# UNITED STATES PATENT AND TRADEMARK OFFICE

10/586,972

Roelof Marissen

<b>Office Action Summary</b>	<b>Application No.</b> 10/586,972	<b>Applicant(s)</b> MARISSEN ET AL.	
	<b>Examiner</b> JAN CHRISTOPHER MERENE	<b>Art Unit</b> 3733

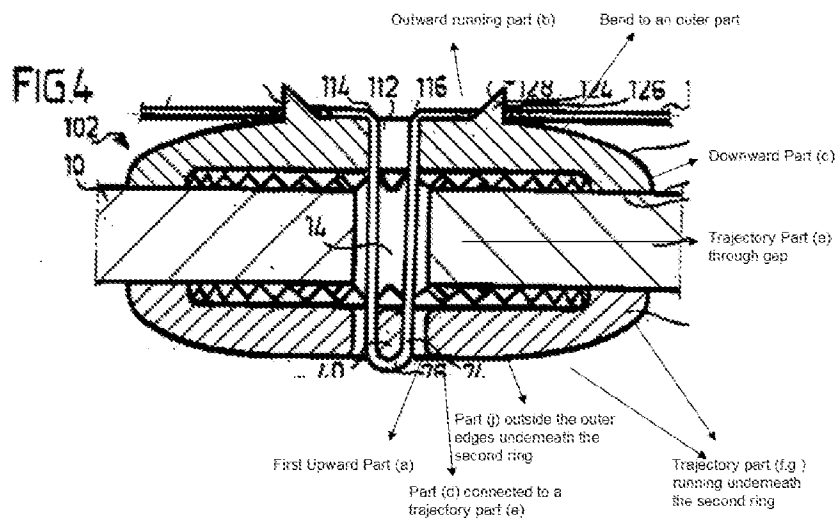
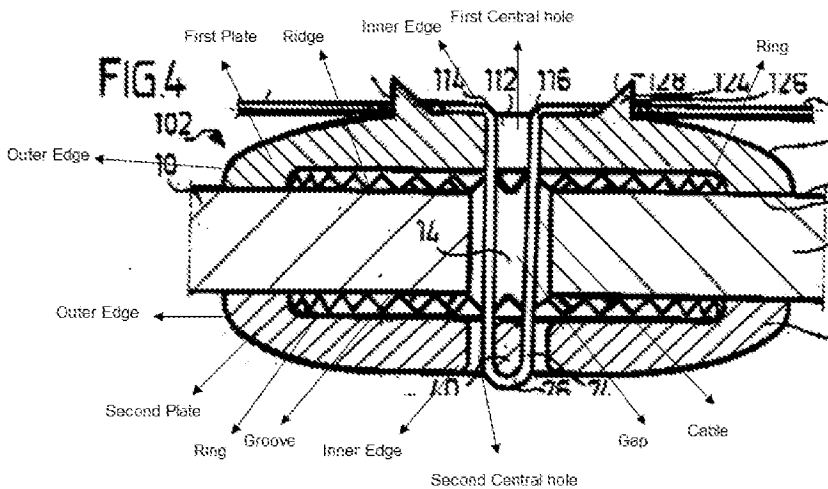
Regarding **Claim 1**, Nesper discloses a fixing device comprising a surgical cable, First and second fixing plates, each plate having a central hole, a ring surrounding the hole, a circumference forming an outer edge, wherein the plates can be stacked on top of each other where the central holes overlap and where a gap can be formed between the plates and one of the plates has a groove and the other plate has a ridge (see fig below), wherein the cable, at least one end of the surgical cable follows continuous trajectory running as part (j) from outside the outer edges underneath the second ring up to the second hole, bending upward into a first upward part (a) running through the second and the first holes a bend to an outward part (b) running across the first ring in the direction of its outer edge downward part (c) outside said outer edge running in a direction opposite to the upward part (a), a part (d) running through the hole of the second ring part (d) at its one end being connected to a trajectory part (e) running through the gap between the first and second fixing plates and at its other end being connected to a trajectory part (f, g) running underneath the second ring and wherein the other end of the cable is connected to the first and second fixing plates (as seen in Fig below, where one can wrap the cable in the trajectory described above).

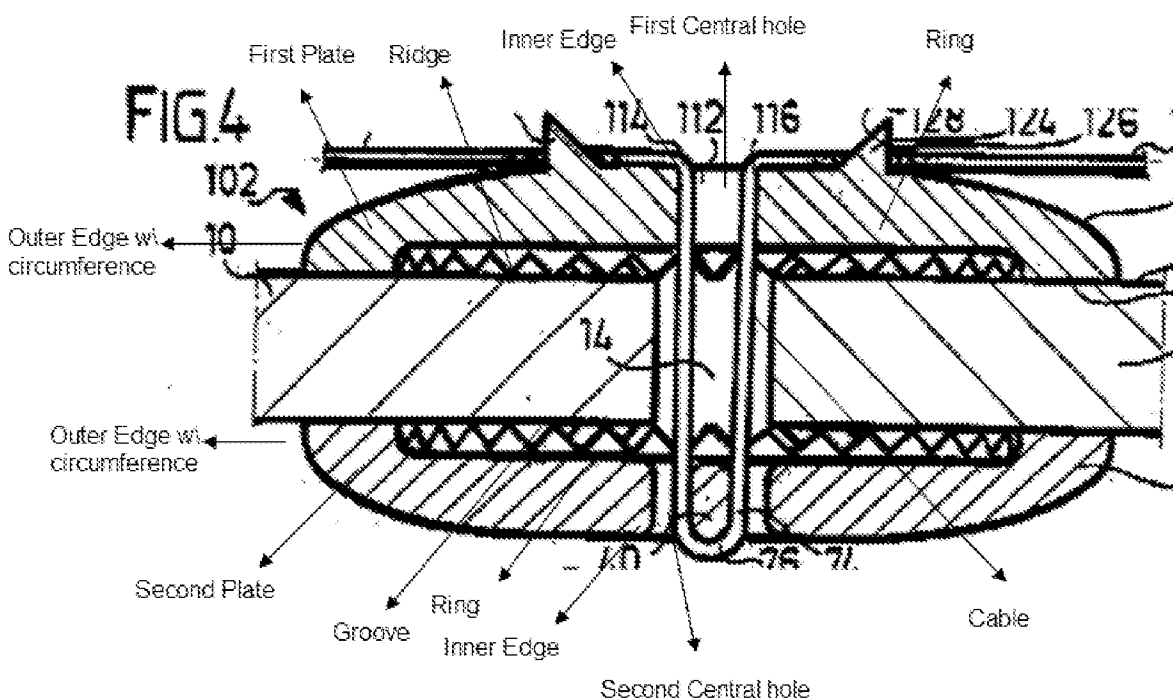
Regarding **Claims 10-11**, Nesper discloses a set of two fixing plates each respectively having a central hole and a ring surrounding said hole, wherein each plate has a circumference forming a nouter edge, an inner edge adjacent to the hole, one of the plates has a surface with a groove, the other plate has a surface with a ridge, and a surgical cable (see Fig below).

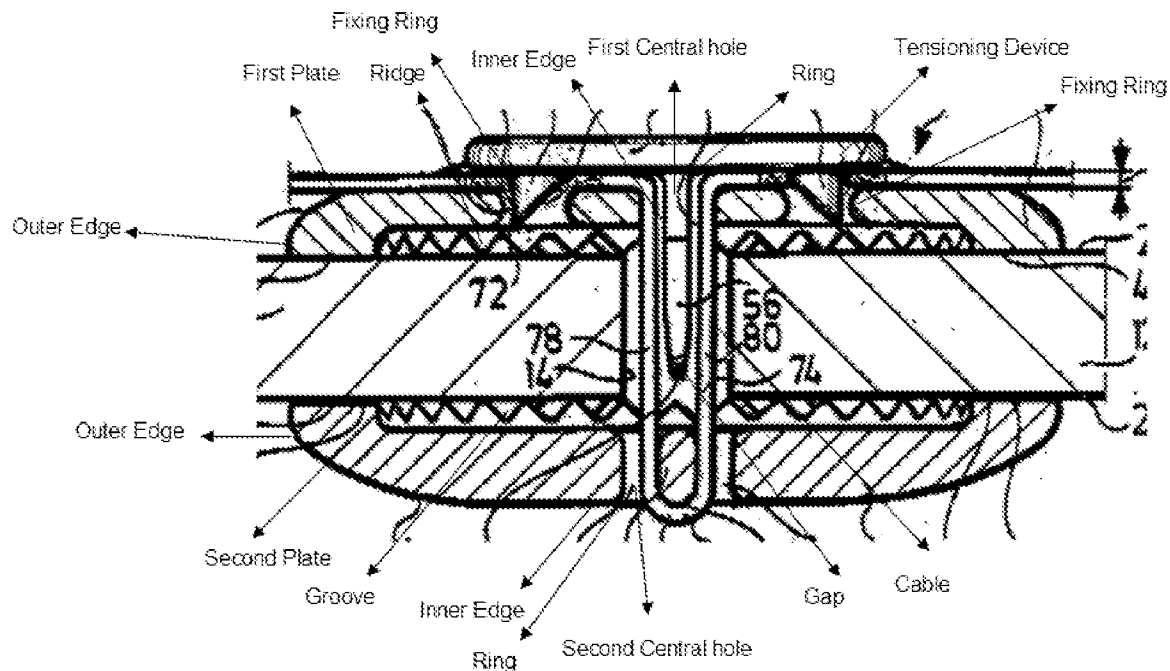
Regarding **Claim 12**, Nesper discloses a surgical cable (#74) as seen in Fig 1) for application in a fixing device according to claim 1 (the examiner notes that the applicant is merely claiming a cable capable of being used in a device as described in claim 1).

Furthermore, the manner in which a device is intended to be employed does not differentiate the claimed apparatus from prior art apparatus satisfying the claimed structural limitations. Ex parte Masham, 2 USPQ2d 1647 (1987).

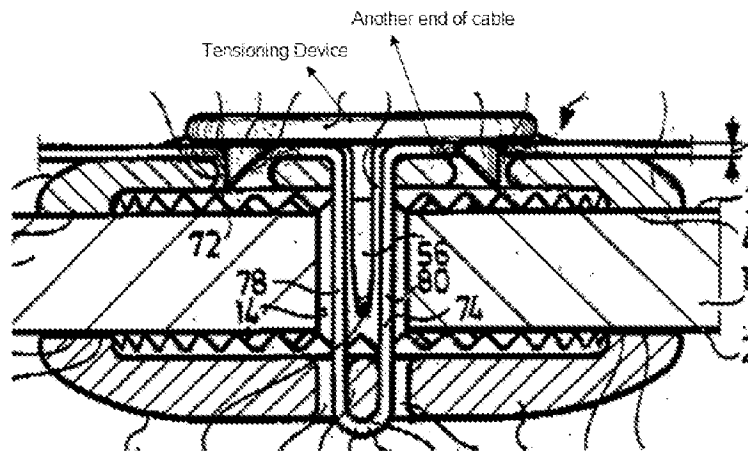
Regarding **Claim 6**, Nesper discloses a tensioning device that is connected to first and second fixing rings, wherein another end of the cable is fixed to the tensioning device (see fig above and below).

Regarding **Claim 9**, Nesper discloses a method for tying bone parts together comprising the steps of applying a bone fixing device according to claim 6 around bone parts to be fixed, followed by drawing said one end (see paragraph 59-60) of the cable to tension the cable around the bone and then tensioning the cable to the tension required to fix the bone parts by means of a tensioning device (see fig above in claims 1, 6 and paragraph 60 and the examiner notes that the applicant is claiming the device

of claim 6, wherein the device is the plates and the cable, wherein the placement of the cables as recited in claim 6 is merely functional and intended use, if the applicant wishes to claim the placement of the cables as recited in claim 1, then the applicant should include those steps in this claim).
